**Notification of a Decision taken by the Cabinet Member for
Regeneration, Environment and Housing**

- Proposed MP1 CPZ extension Watery Lane – Statutory
Consultation

Subject: Proposed MP1 CPZ extension Watery Lane – Statutory Consultation

Representations and Officer's Comments

Drawing No.
Z/8-2/8-04

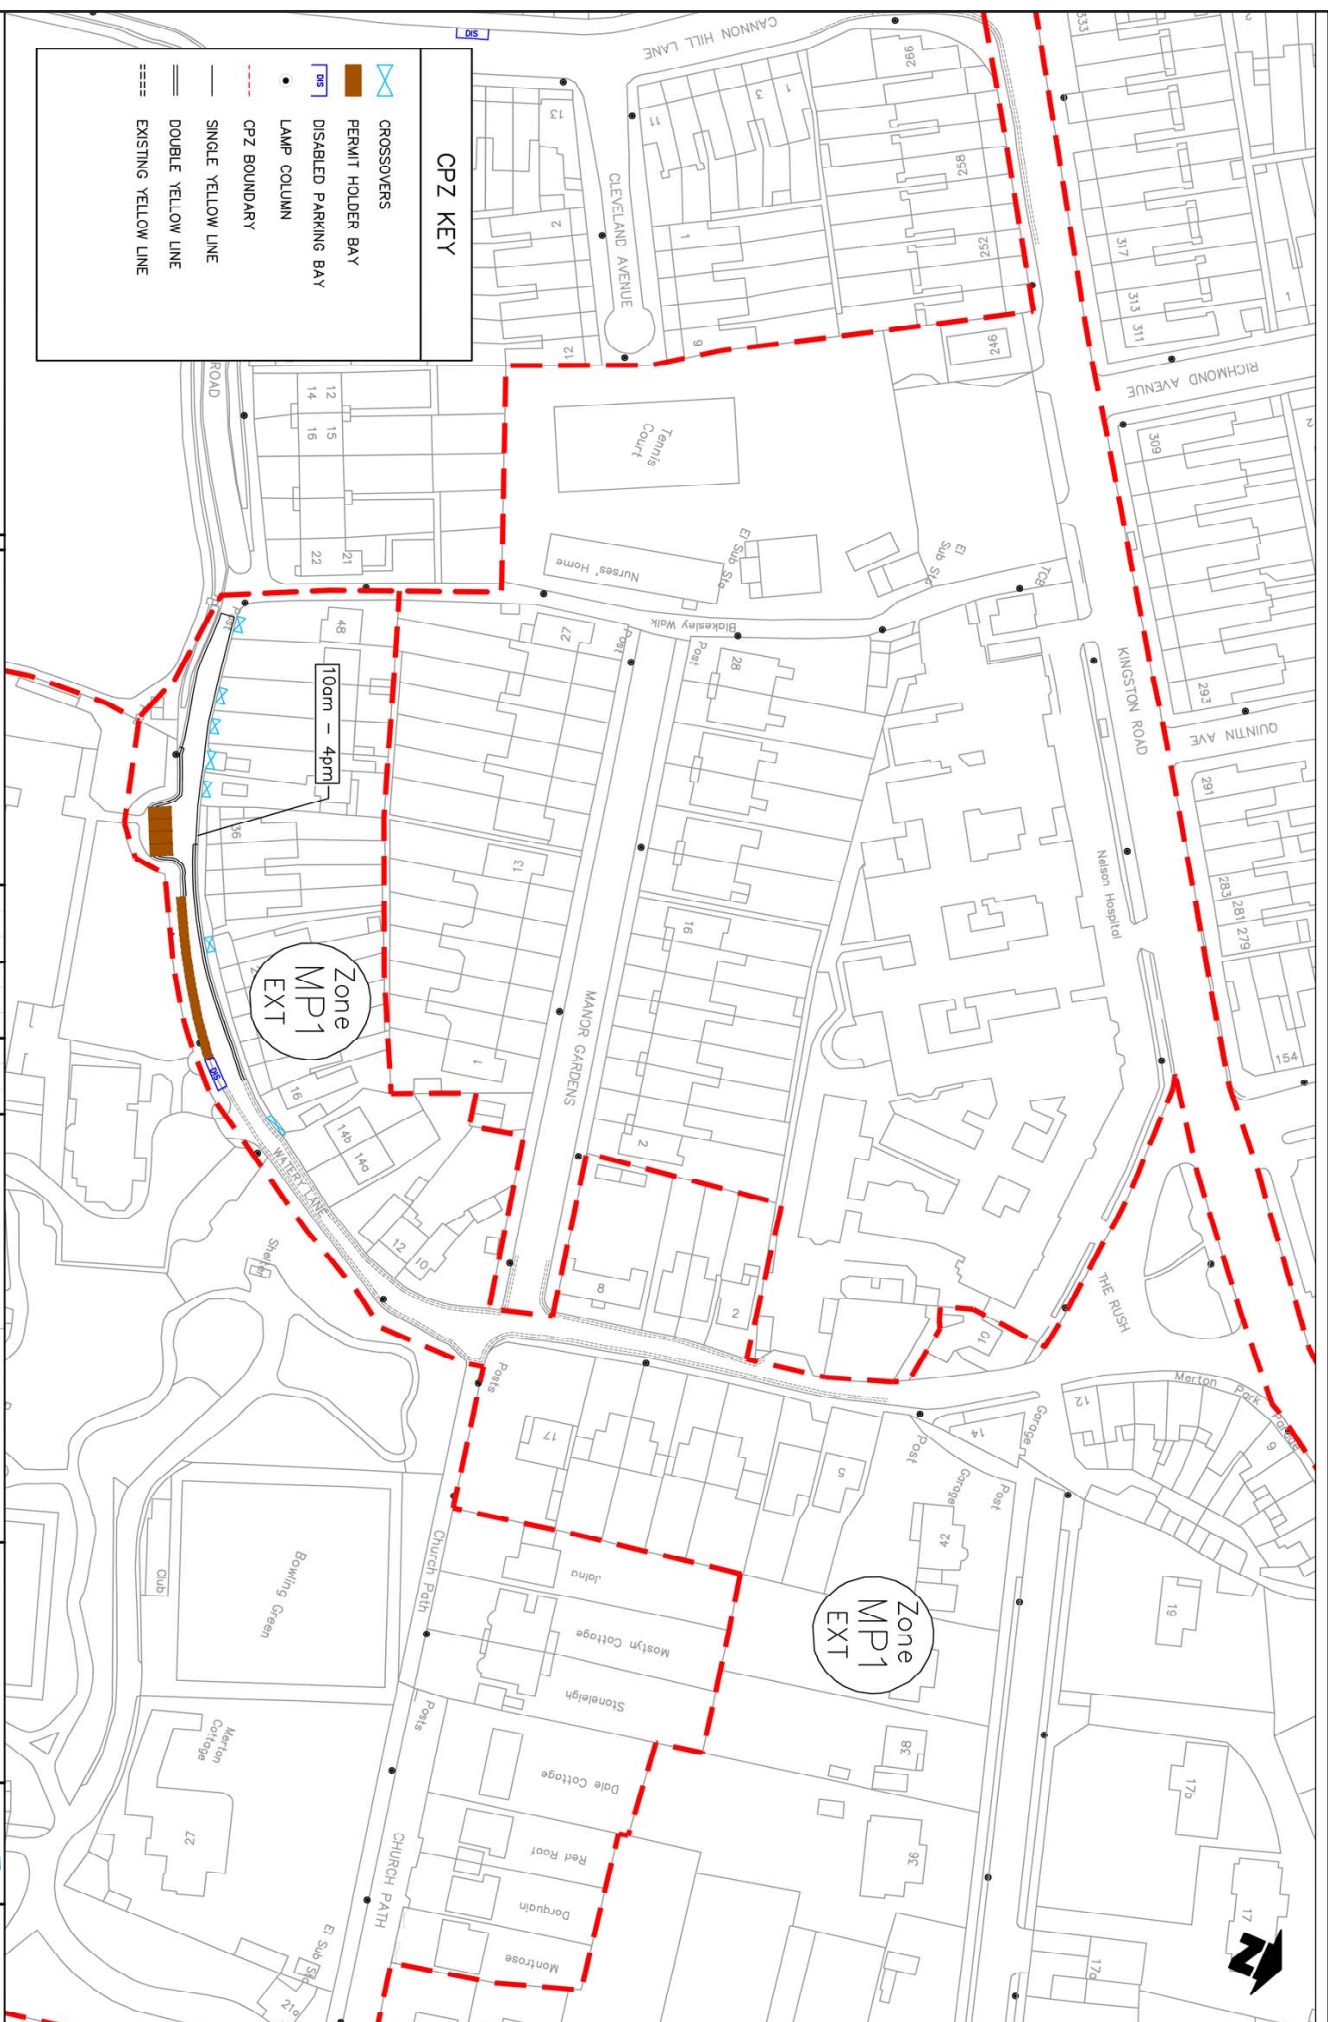
We agree in general to the 5 main propositions set out in the documentation, and the accompanying drawing Z78-218-04.

1. *There is room for 5 perpendicular spaces in the D, rather than the 4 as shown on the plan. The footway around the western curve of the D is little used since the new gates to the Cricket Ground were installed, and a further perpendicular parking space could be added at this end using much of the (redundant) pavement. In any event, the proposed double yellow lines round the curve do not need to reach so far into the D. There are no safety issues here to do with sight lines or cornering, and the footway is more than 2 mètres wide.*

2. *The overall width of the Lane, plus its two footways, should make it possible to extend the footway parking on the south side of the Lane to opposite no 32. At this point, with a standard sized car parked partly on the footway, there is 2.9m of road carriageway, plus 1.2m of footway on the north side of the Lane to allow a large vehicle to pass. Please also note that no vehicle wider than 3 metres can gain access to the Lane because of its narrowness outside nos 12-14., and that the provision of parking spaces in Manor Road (in MP2) in places leaves less than 3 metres between a much tighter road edge and the parked cars. We believe that Watery Lane should be treated with the same flexibility.*

- Watery Lane to be included as an extension to MP1 CPZ operating Monday to Friday between 10.00am and 4pm – we fully support this proposal.
- We also support the proposed parking spaces on the north side between nos 18 and 26 being re located to the south side partially on the footway. The proposed spaces terminate opposite no 30 but we feel this could be extended to no 32, given that the risk of obstruction has been overcome by the proposed provision of double yellow lines on the houses side of the highway, this would provide one further space.

- We feel the 4 parking spaces in the "D" outside the western end of the school could accommodate 5 spaces if they are allowed to lap the footpath on the western side which is rarely used, this arrangement would not obstruct the new pedestrian access to the recreation ground and would compensate for the loss of a parking space opposite nos 38 / 40 Watery Lane.

- 1) It is not clear from your diagram (on an A4 sheet) exactly where the new double yellow lines are to be applied, nor is it much clearer from a larger copy (on computer screen) of this diagram obtained from your website at www.merton.gov.uk/cpzmp1ex.
- 2) While I understand that 10:00-16:00 is the standard operating time for the rest of CPZ MP1, given the special

3) From what I can make out from your diagram, it looks as if you are only allowing 4 parking spaces in the "D" at the western end of the school frontage. If partial width pavement parking is allowed and the outer vehicles are "staggered" slightly northwards (and progressively more so the further they are away from the centre vehicle), it will be possible to get 5 vehicles in that part (and you can see 5 vehicles parked there, leaving room for pedestrians to pass, on most days). This is shown in the attached (hand-drawn!) diagram (not drawn to scale). **If this diagram is not clear (I was never much good at Art at school!) I can either provide the original or I can take it to you so that I can explain it (I can be contacted by phone on 07918 088712 or (020) 8540 7013, or by e-mail at clarke.nick@btinternet.com). Or we can even discuss it "on the ground".**

4) With suitable road/pavement marking to show the allowed extent of parking on the pavement (and also the parking spaces in the "D") it will probably be possible to remove the proposed double yellow lines opposite numbers 32 and 34 (which takes up the space of 1/2 to 1 vehicle). Parking spaces are at a premium here in this street, so we need all the parking spaces that we can wring out of this scheme (especially since there will now be no potential space[s] opposite 38-40)!

As regards the other proposed changes the one area I would draw your attention to is the proposal for 4 perpendicular parking bays in the 'D'. The current practice is for 5 perpendicularly parked cars in this space, without any inconvenience for pedestrians using the school entrance or the new entrance to the cricket field. With the relocation of the disabled parking bay, which currently takes up one oversized space, I believe the 'D' can continue to accommodate 5 perpendicularly parked cars without issue, and suggest this should be incorporated in the final plan.

I had a look at the plans attached and extract below I counted 11 spaces. Given that there are 12 households that do not have usable drives to park their car, and some households having two cars to maintain modern family life. Merton's plan to provide 11 parking spaces is **not** enough. The minimum we requested during our consultation on the 20th September was **14**.

However, we thought we should point out that your map does not show the crossovers outside our house No. 3 (and our neighbour at No.1) which serve as our driveways. It does not look like any additional street furniture would be included if the scheme goes ahead, but we wanted to ensure our driveways were noted so nothing goes across them.

With regards to the D section, See section 4.7 of this report. With regards the footway opposite property number 32, the section is too narrow for a regulated parking space.

With regards to the D section, See section 4.7 of this report . With regards the footway opposite property number 32, the section is too narrow for a regulated parking space.

With regards to the D section, See section 4.7 of this report. With regards the footway opposite property number 32, the section is too narrow for a regulated parking space.

With regards to the D section, See section 4.7 of this report. With regards the footway opposite property number 32, the section is too narrow for a regulated parking space.

Noted. This part of the road already has double yellow lines. The crossover not marked on the plan does not add or reduce parking space.
